# APPENDIX B – UPDATED PROJECT DESCRIPTION – SSD-10448 MOD 10

## Project Description SSD-10448

Insert new Figure 1: Concept Proposal

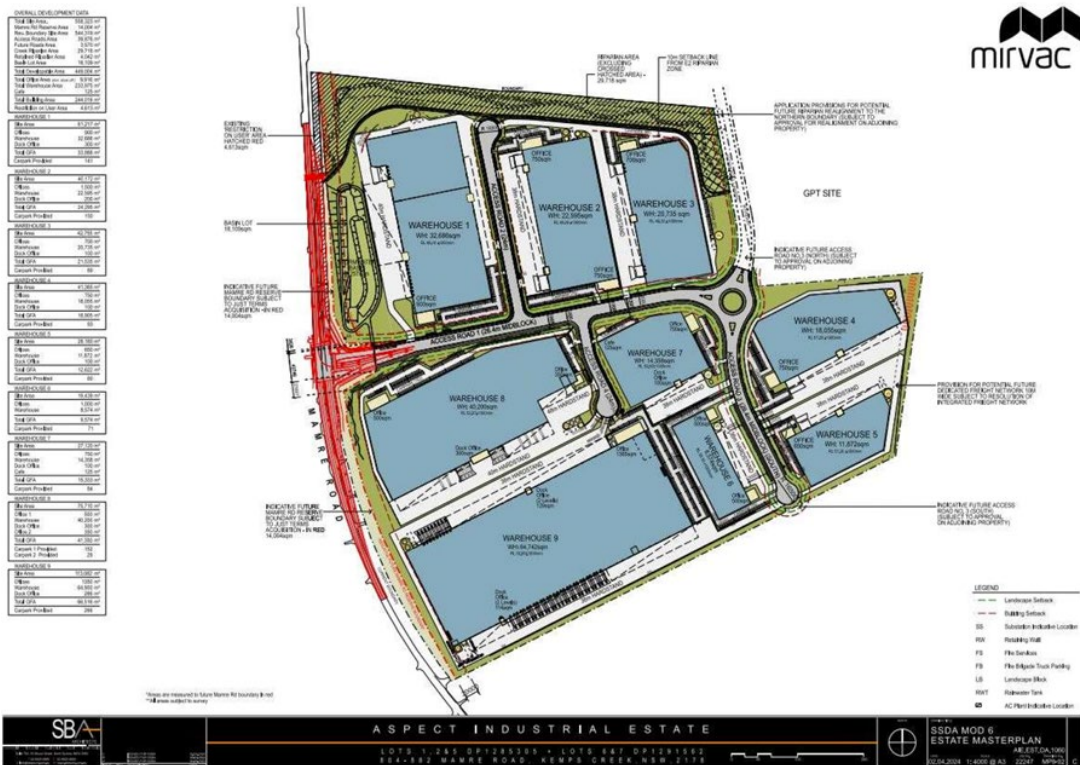
Delete Figure 1: Concept Proposal
